# TOWARD A CONNECTED MONTLAKE LID

An urban design review of Seattle's SR-520 Replacement project

Using drawings from WSDOT's 2012 Community Design Process, this document highlights failures and opportunities to connect the Montlake Lid with neighborhoods, parks, light rail and UW.

EXISTING MONTLAKE BLVD

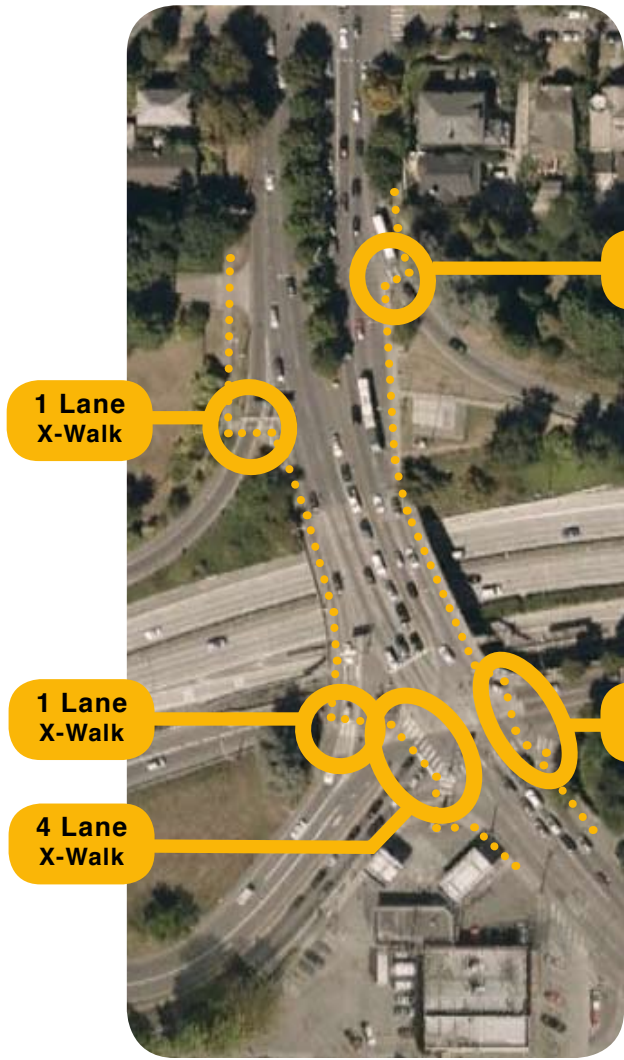
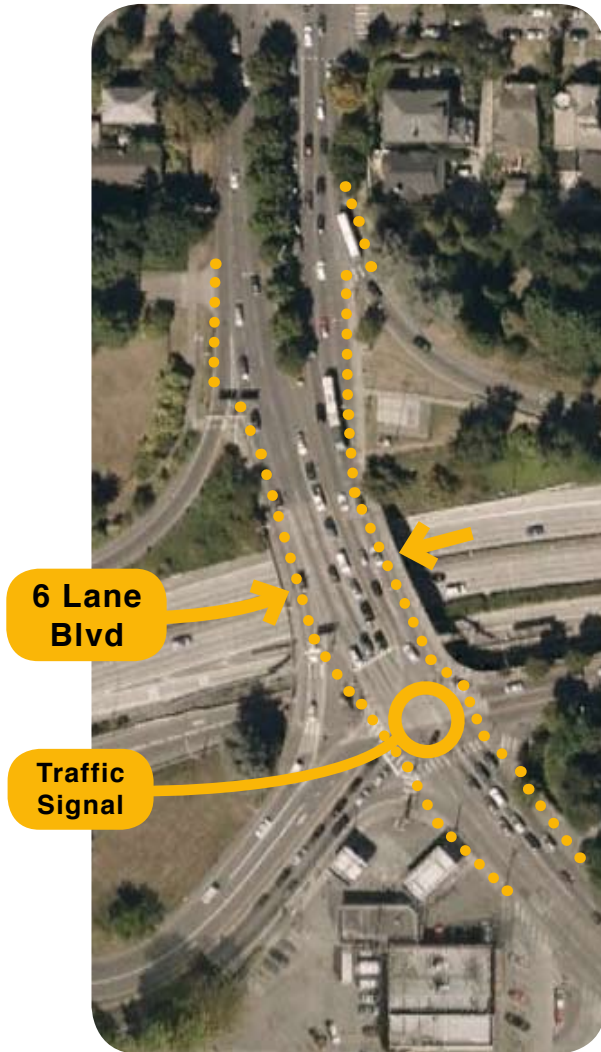
The pedestrian environment of Montlake Blvd is already poor.

Bigger intersections, more lanes to cross & increased traffic will make walking even more difficult.

Encourage walking by providing safe, direct & traffic-separated routes

Mixing pedestrians & bicycles on sidewalks creates conflicts.

Larger intersections create more conflicts for bicycles in traffic.

Consider cycle tracks or other traffic-separated routes for bicycles

PROPOSED MONTLAKE BLVD

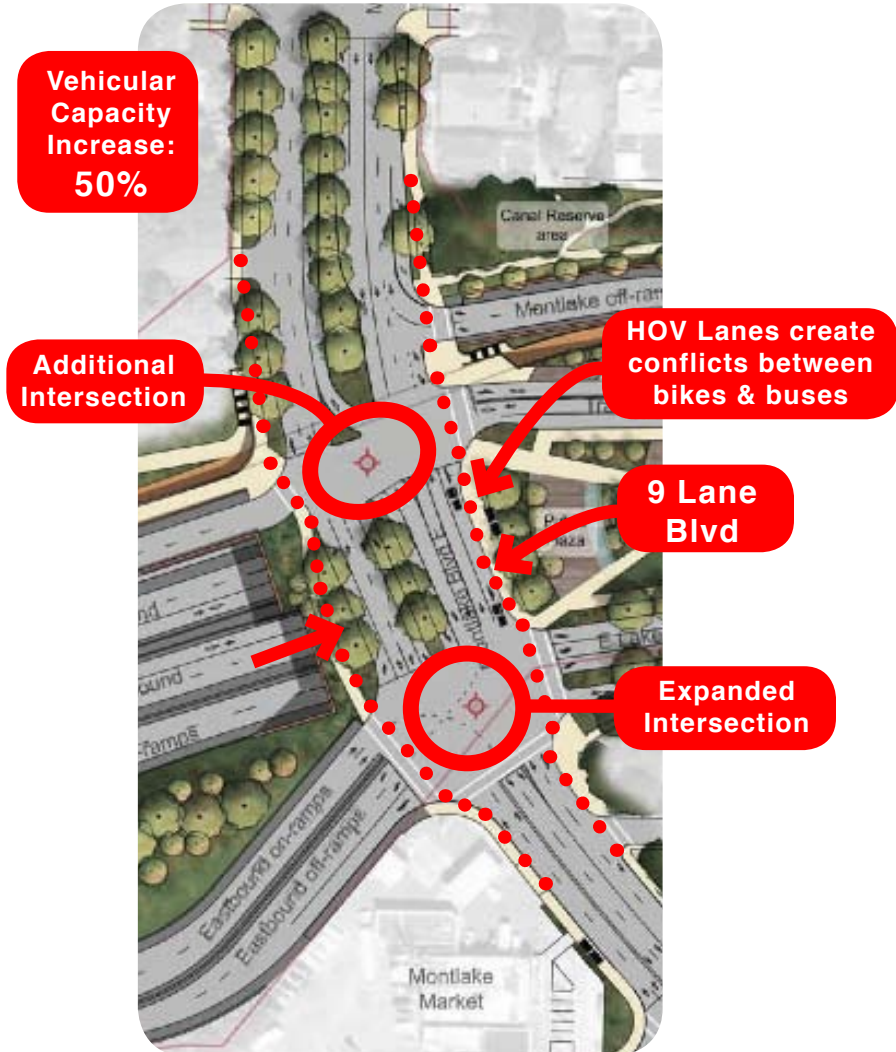
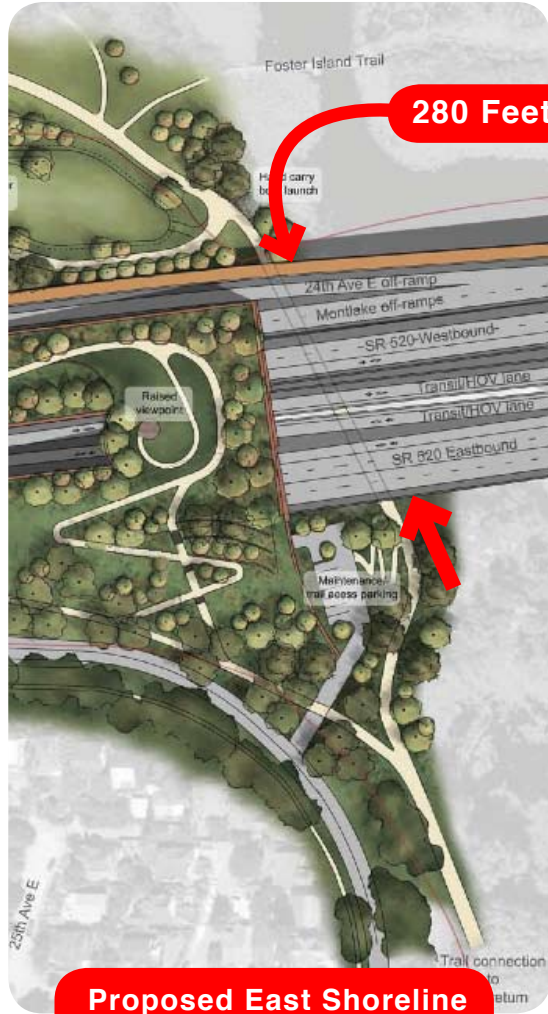
HOV Lanes create conflicts between bikes & buses

Proposed East Shoreline with Underbridge Trail

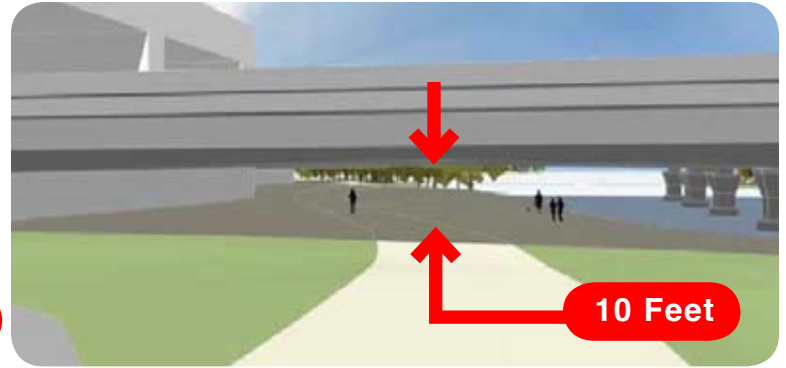
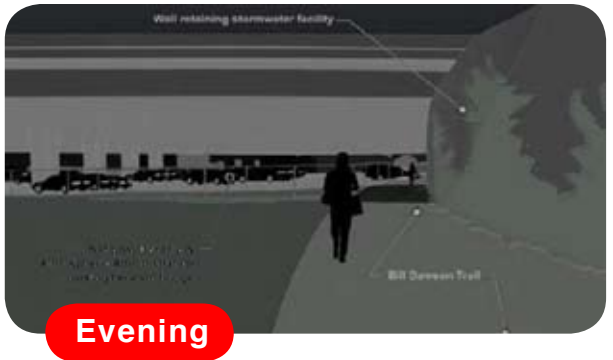
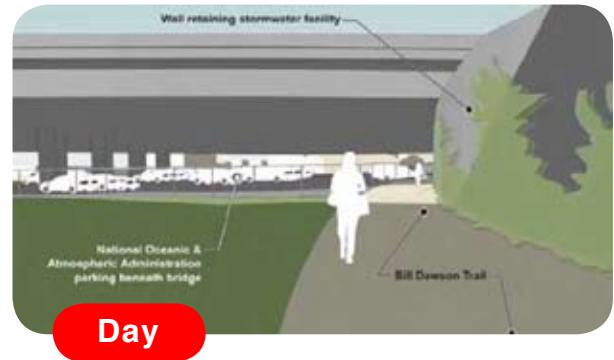
Underbridge areas are low, dark & potentially dangerous

Underbridge areas are low, dark & potentially dangerous

Use lids to make safe, direct and above-bridge trail connections

Use lids to make safe, direct and above-bridge trail connections

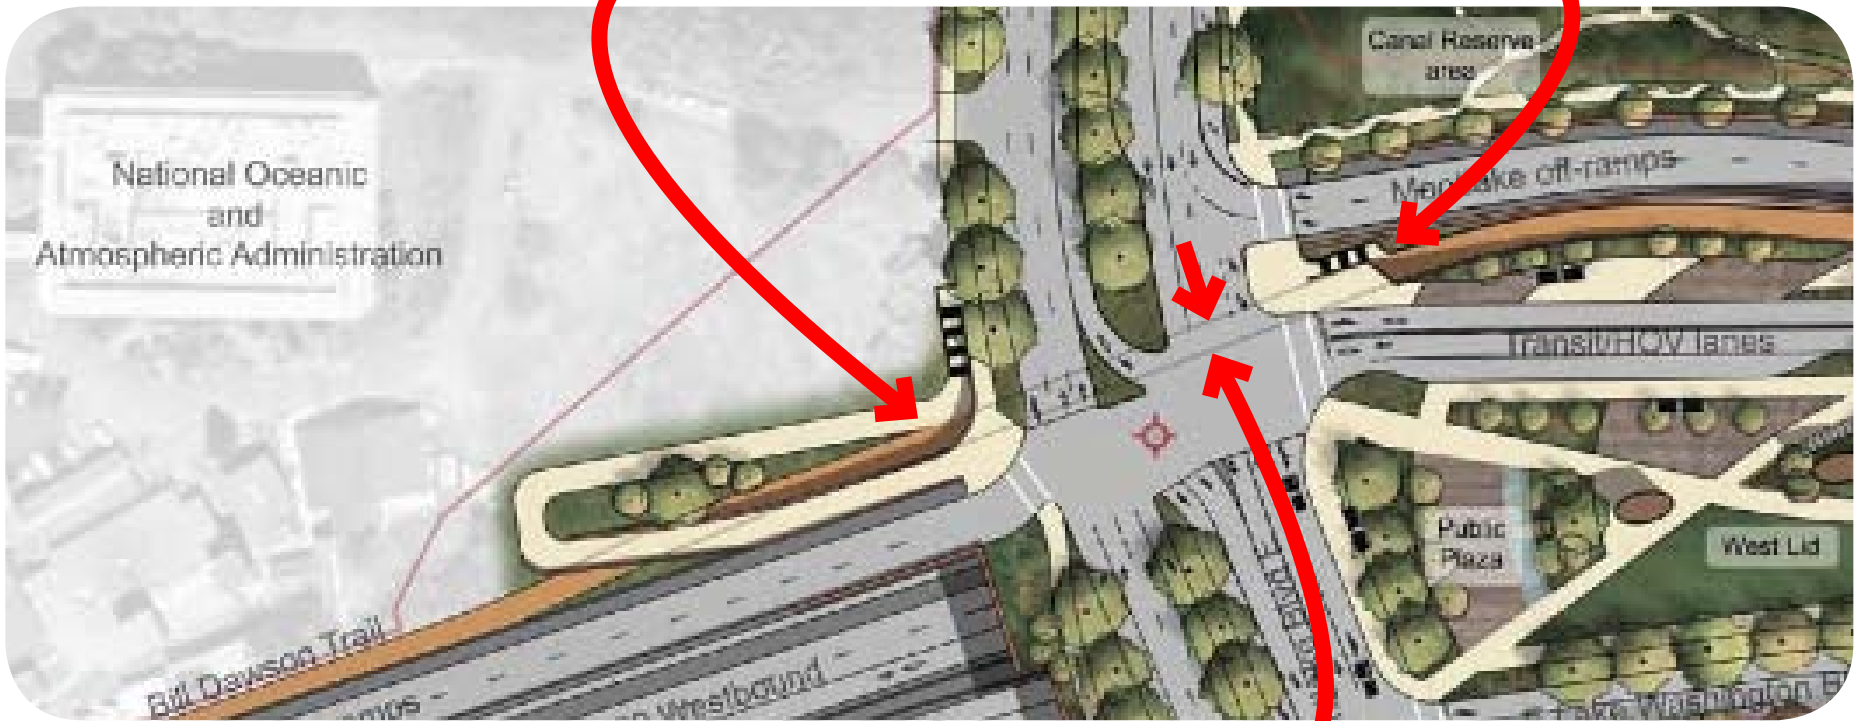
Fast moving bikes will conflict with pedestrians

Blind stair landing next to tunnel entrance.

Bicycles U-turn across traffic

Narrow tunnel will feel unsafe after dark.

Poor connection: Pedestrians and bicyclists must cross ramp traffic.

Widen tunnel to create separate paths for bikes & pedestrians.

Consider overpass option to increase safety

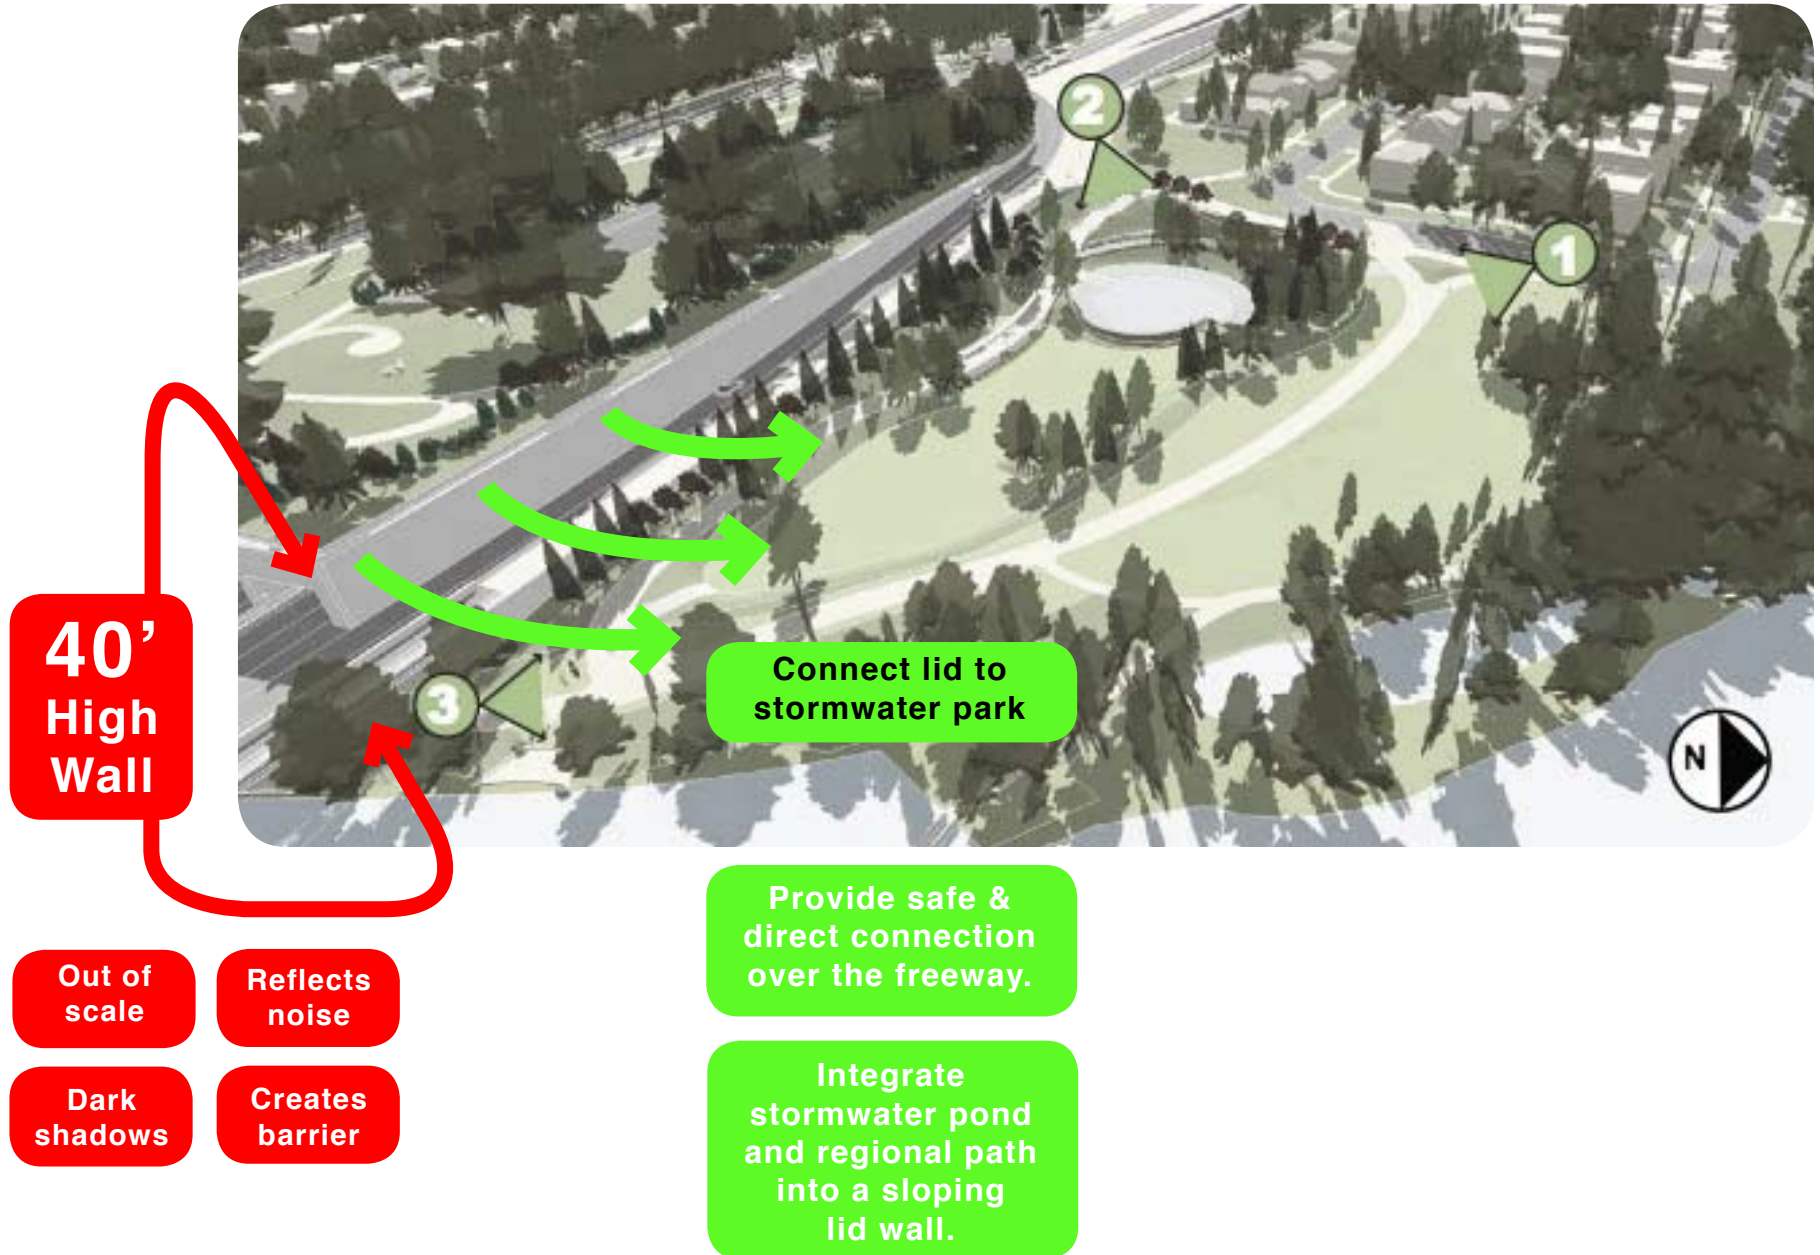
Traffic lanes discourage access to park space.

Open space will feel isolated and unsafe.

Connect lid to stormwater park (see next page).

Consider ways to naturally ventilate tunnel & remove O&M facility.

Create multiple smaller lids for better connectivity.

# -- 8 -- CONNECT WITH NEIGHBORHOOD GREENWAYS FOR SAFE & DIRECT PASSAGE OVER 520

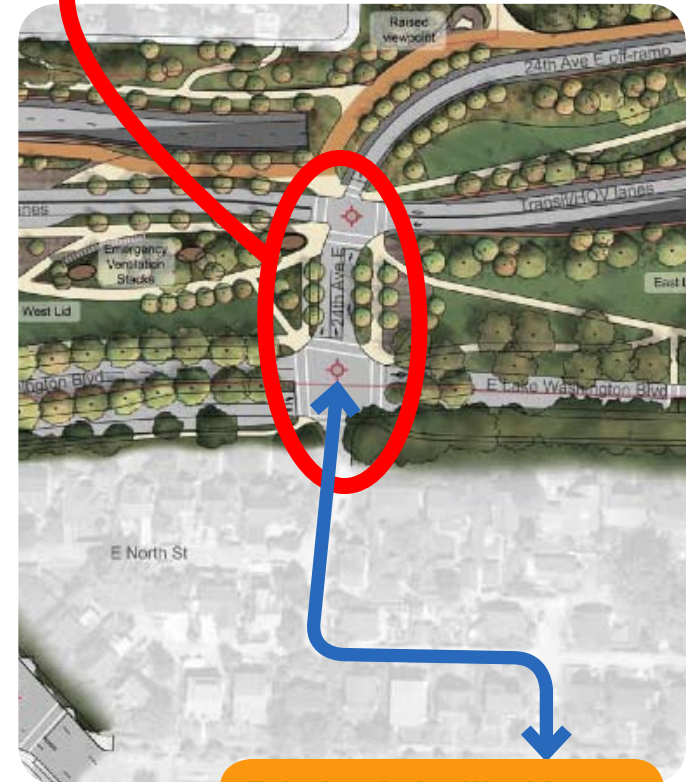
Greenway ends without...

... a safe, direct and traffic separated path over 520.

Existing bicycle route to become freeway access road.

# -- 10 -- CONNECT PORTAGE BAY BRIDGE TRAIL TO MONTLAKE BLVD

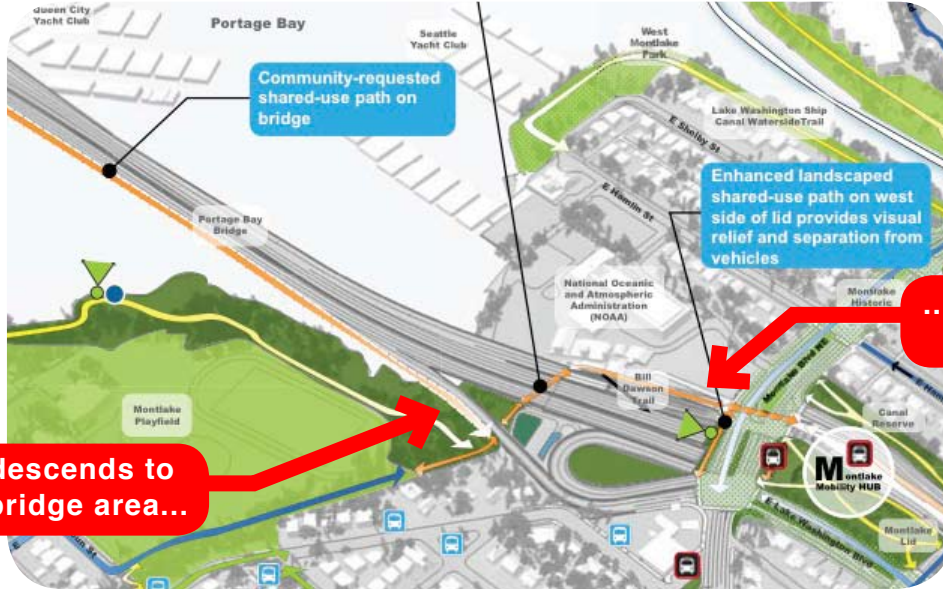
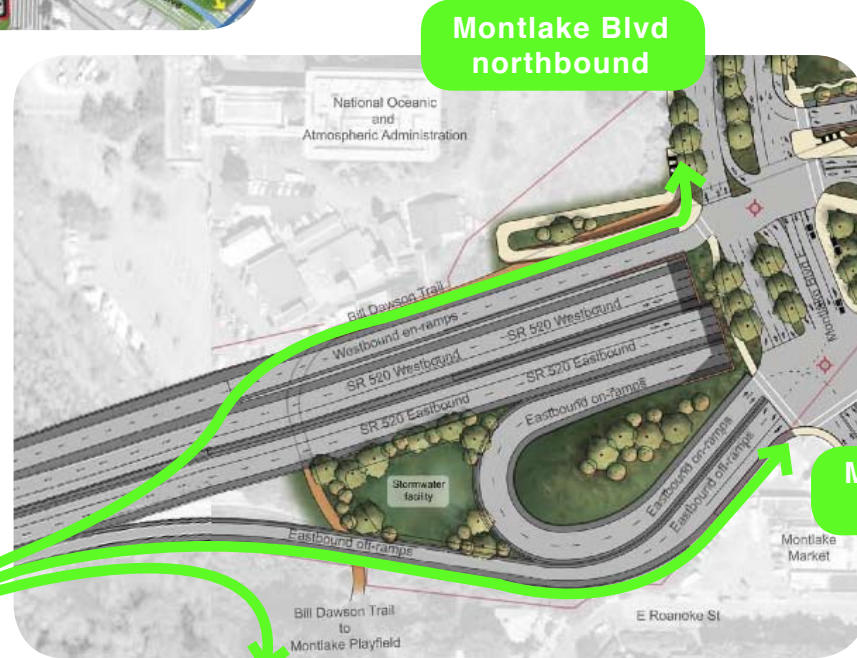
...with arduous climb up to Montlake Blvd.

Trail descends to underbridge area...

Connect Portage Bay Bridge Trail to...

...Montlake Playfield  
...Local Streets
